LYDIA LEIS ADDITION TO SEDGWICK COUNTY, KANSAS

RE: SUB 2002-67 -- One-Step Final Plat of Lydia Leis Addition

CASE NUMBER: SUB 2002-67 -- LYDIA LEIS ADDITION

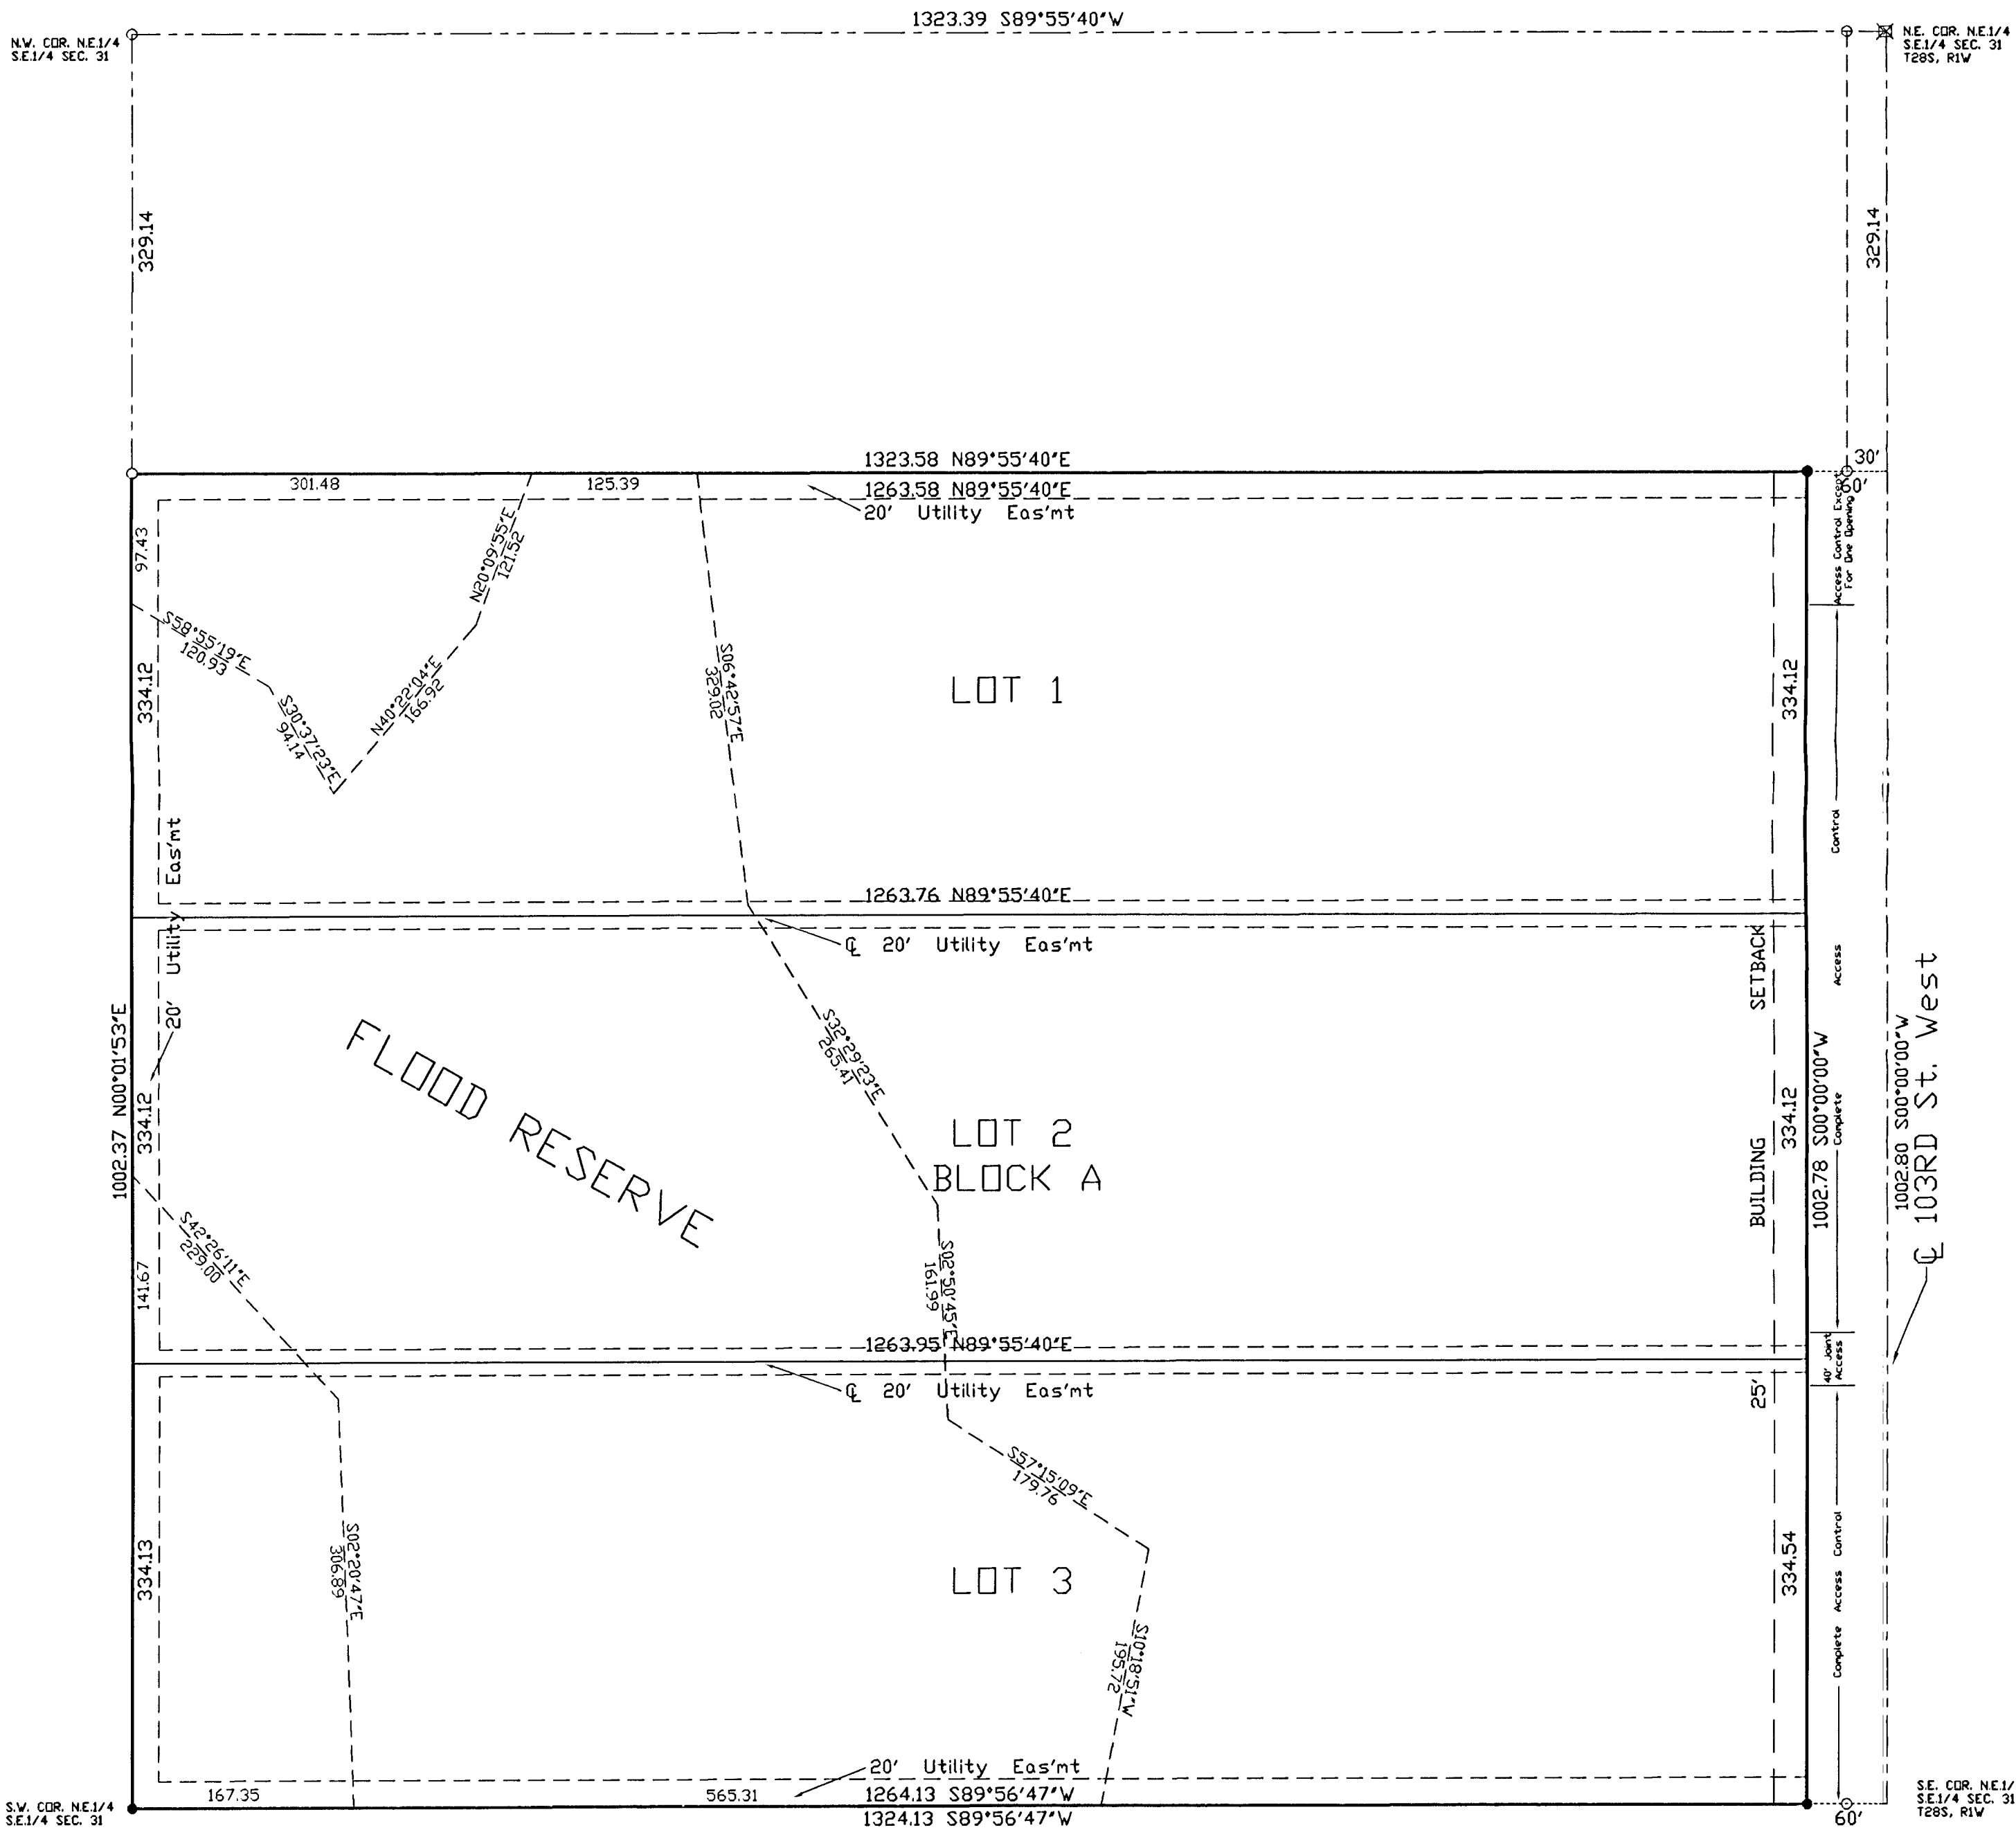
- D. **County Engineering** needs to comment on the status of the applicant's drainage plan. **A drainage plan is needed. A floodway reserve needs to be platted.**

- E. **County Engineering** needs to comment on the access controls. The plat proposes two access openings along 103rd St. West, including one joint opening between Lots 2 and 3. **Two openings have been approved. The opening for Lot 1 shall be located along the north property line.**

- H. On the final plat tracing, the MAPC signature block needs to reference "J.D. Michaelis, Chair".
- I. The signature line for the County Commissioners Chairman needs to reference "Ben Sciortino".

- J. The Applicant is advised that if platted, the building setbacks may be reduced to 25 feet to meet the 85-ft setback required from the centerline of County section line roads.

- K. Approval of this plat will require a waiver of the lot depth to width ratio of the Subdivision Regulations for all three lots. The Subdivision Regulations state that the maximum depth of all residential lots shall not exceed 2.5 times the width.

- L. The platator's text shall include language that a drainage plan has been developed for the plat and that all drainage easements, rights-of-way, or reserves shall remain at established grades or as modified with the approval of the applicable City or County Engineer, and unobstructed to allow for the conveyance of stormwater.

- N. The applicant's engineer is advised that the Register of Deeds is requiring the name(s) of the notary public, who acknowledges the signatures on this plat, to be printed beneath the notary's signature.
